Service Bulletin

Cargo Door Forward Slide, operating rod and handle.

SB-GA8-2020-23
Issue 4

Figure 3: Worn slider indicating where to measure.

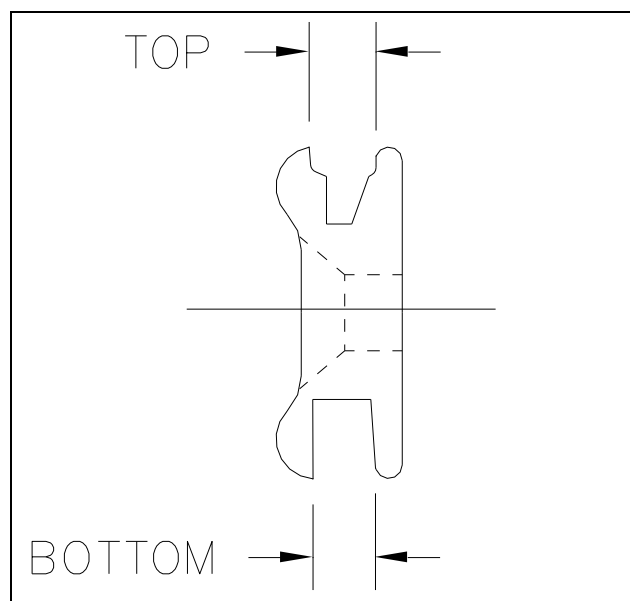
3. Figure 3 below shows how a worn part normally looks and where to measure the groove width. The TOP and BOTTOM profile differs on a worn part and as such both the top and bottom slide grooves are to be measured with a calliper.

4. Measure the groove width and if the groove is wider than 0.145" at any point along the slider or if the part is cracked or excessively worn a new slider, Item 1, must be fitted.
5. Irrespective of Item 1, Items 2 to 7 MUST be fitted as shown in Figure 4 and listed in below.

Figure 5: Checking with the Forward Slide Gauge (all four corners require checking)

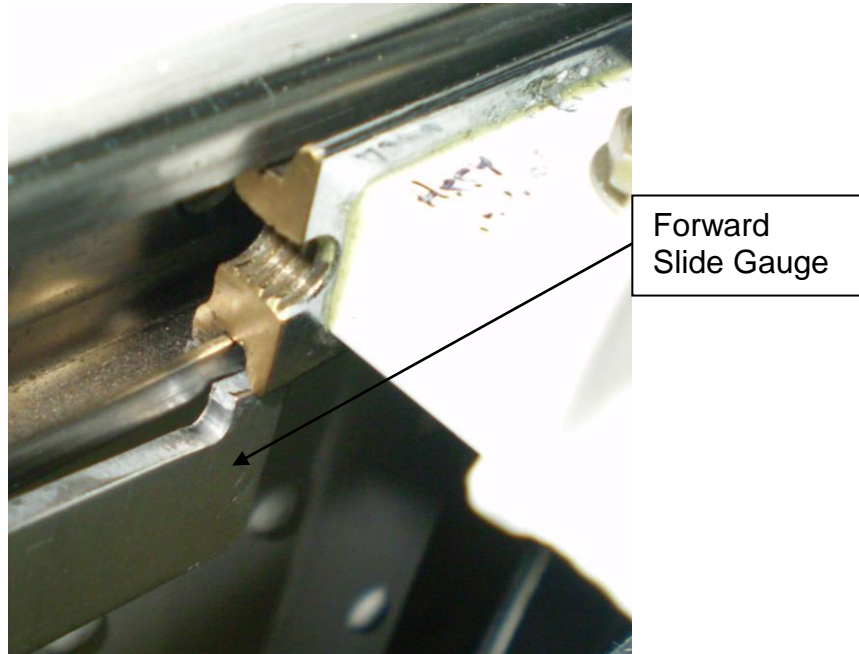
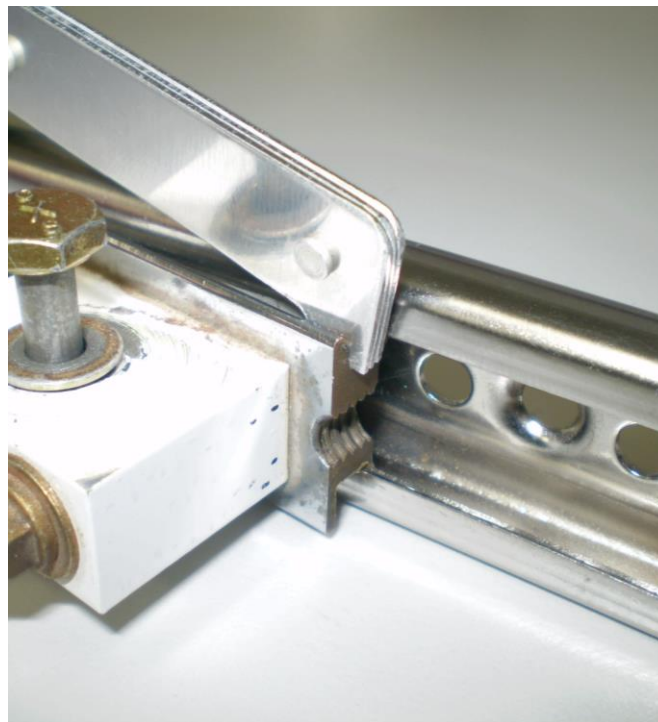
1. Open the door handle so that the door swings out to gain access to the slider (see ACTION 1, Para 1)
2. Try to insert the Forward Slide Gauge (Item 8, Table 2) between the slider and the track as shown in Figure 5 and Figure 6 below. Standard Feeler gauges made up to 0.098" (0.023"+0.024"+0.025"+0.026") may also be used.

3. If it is possible to fit the Forward Slide Gauge or feeler gauge between the track and slider (as shown in Figure 6 above) at any of the four corners carry out ACTION 1 Para 2 to 4.

Figure 8: Rear Door Handle Mechanism - Inspection Areas

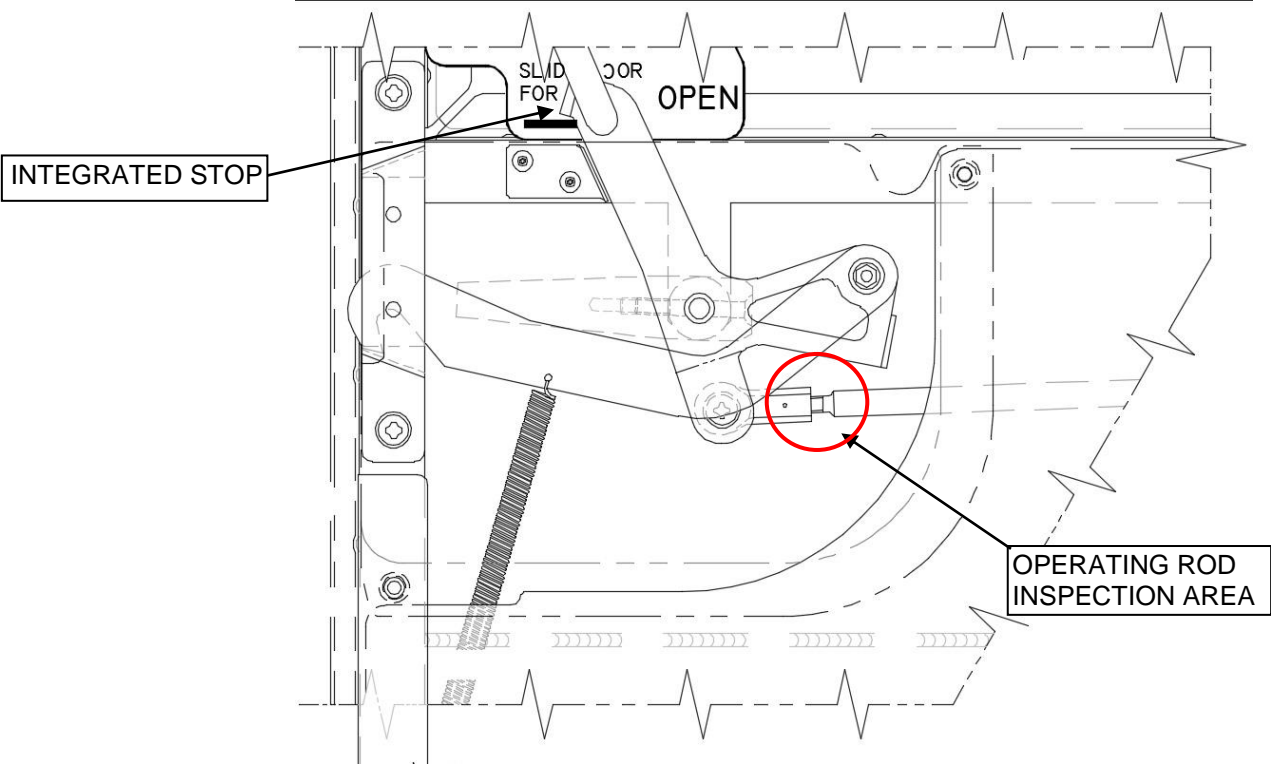
1. Remove Rear Mechanism Cover, refer to Figure 7.
2. Inspect threaded stud at the end of the operating rod, refer to Figure 8. If there is any indication of bending then either replace the operating rod with Item 9 from Table 3 or locally modified rod detailed in Part B2 using the following steps.
3. Disconnect the rod ends from the handle and pivot arm. Remove the forward rod end and pull out the operating rod.
4. Install the operating rod through frame bush prior to installing forward Rod End. Install rod ends and connect to the handle and pivot arm.

Figure 9: Rear Door Handle Pivot Post – Rework Area

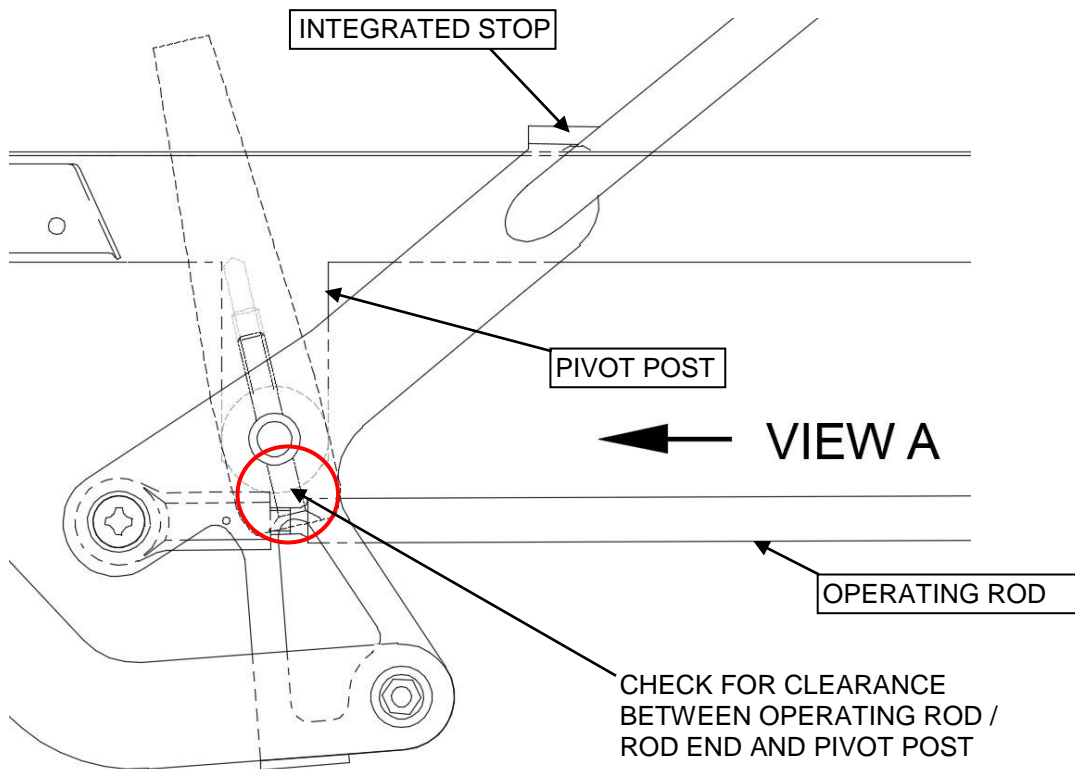
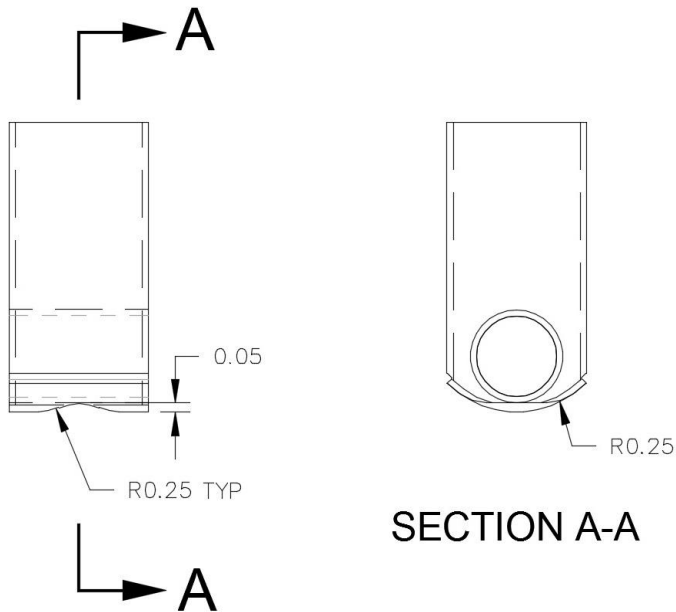
5. With the door handle held fully open / against the stop, check that the operating rod does not hard foul against the rear door handle pivot post, refer to Figure 9. If required rework the rear door handle pivot post.
6. Reinstall the Rear Mechanism Cover, refer to Figure 7.

1. Only Pivot post shown for clarity
2. Rework using blending guidelines of AC43.13-1B Chapter 6 Section 7 and 10
3. Ensure rod end and rod have a min clearance of 0.040in from pivot post
4. Restore surface protection IAW Service Manual

Figure 12: Rod Modification (P/N: SB-GA8-2005-23-02)

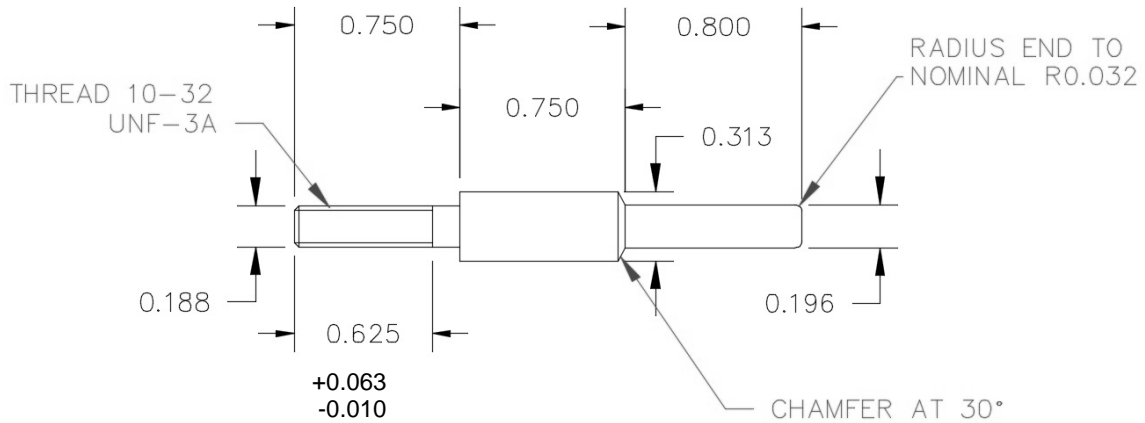
1. From 4130 Rod (MIL-S-67580.0500 manufactures 1 off Rod End Repair SB-GA8-20005-023-01, as shown in Figure 10.
2. Trim 0.75in from the end of the operating rod, chamfer at 30° and drill two Ø0.188in holes, refer to Figure 11.
3. Weld Rod End Repair SB-GA8-20005-023-01 to the trimmed rod, refer to Figure 12.

1. NOT TO SCALE
2. Weld in accordance with Cahp 51-20-00 of the GA Service Manual. Grind / finish all welds flush. Filler wire / consumable AWS 5.28: ER80S-B2 or equivalent
3. Apply primer 2.0in past the repair area that conforms to MIL-PRF-23377K (or later approved revision) or FEDSPEC-TT-P-1757B (or later approved revision). Apply topcoat of paint that conforms to MILPRF-85285E (or later approved revision) and matches the surround colour.
4. Using indelible ink, permanently part mark the modified operating rod as SB-GA8-2005-23-02
